Work Order ID 129550

Item ID: D5159-045 Accept ***N900040100*** Setup Start ***NS1***
 Revision ID: Stop ***NS2***
 Item Name: Seat Rib Assembly
 Start Date: 2/13/2015 Start Qty: 6.00 ***6*** Cust Item ID:
 Required Date: 2/20/2015 Req'd Qty: 6.00 ***6*** Customer:
 Reference:

A	NEW ISSUE	AJS	14.09.24
REV.	DESCRIPTION	BY	DATE
DESIGN	AJS	DART AEROSPACE LTD HAWKESBURY, ONTARIO, CANADA	
DRAWN	AJS	DRAWING NO. REV. A	
CHECKED	AP	D5159 SHEET 1 OF 3	
MFG. APPR.	DD	TITLE SCALE	
APPROVED	HS	SEAT BRACE ASSY NTS	
DE APPR.	DS	DATE 14.09.24	
COPYRIGHT © 2014 BY DART AEROSPACE LTD THIS DOCUMENT IS PRIVATE AND CONFIDENTIAL AND IS SUPPLIED ON THE EXPRESS CONDITION THAT IT IS NOT TO BE USED FOR ANY PURPOSE OR COPIED OR COMMUNICATED TO ANY OTHER PERSON WITHOUT WRITTEN PERMISSION FROM DART AEROSPACE LTD.

ITEM	QTY -045	P/N	DESCRIPTION
	X	D5159-045	SEAT RIB ASSY
1	1	D5159-3	SEAT RIB
2	1	D5160-3	SHIM
3	3	MS20601M4W4	RIVET, BLIND, CSK (MONEL)

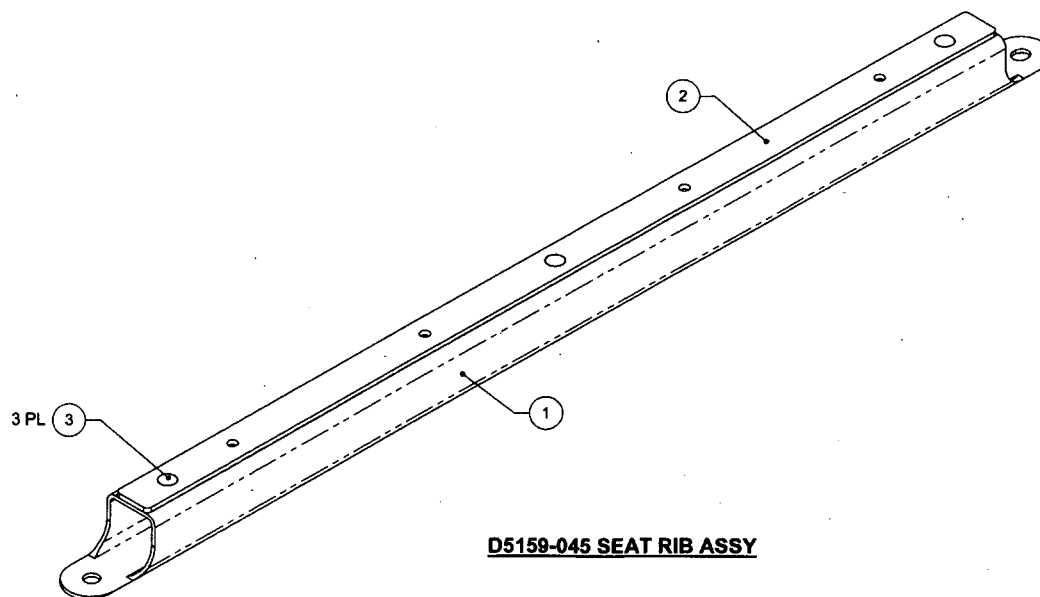
Root Cause	Date	Step	Qty	Description of work order update or non-conformance	Initial Chief Eng	Action Description	Sign & Date	Verification	QC Inspector
Design	15.03.03	110	6	MS20601M4W4 COLLAR BREAKING INCORRECTLY	A.P. 15.03.03	ACCEPTABLE TO REPLACE WITH EQUIVALENT "AD" RIVET, MUST BE INSTALLED WET WITH ARDSEAL 890 B2		DAS 38 9-89 MAR 03 2015	
Doc/Data									
Equip/Tooling									
Handling/Pre									
Material									
Operator									
Offset/Setup									
Process									
Supplier									
Training									
Transport									
Unapproved

ACCEPTABLE
SUBSTITUTE
A.P. 15.03.03
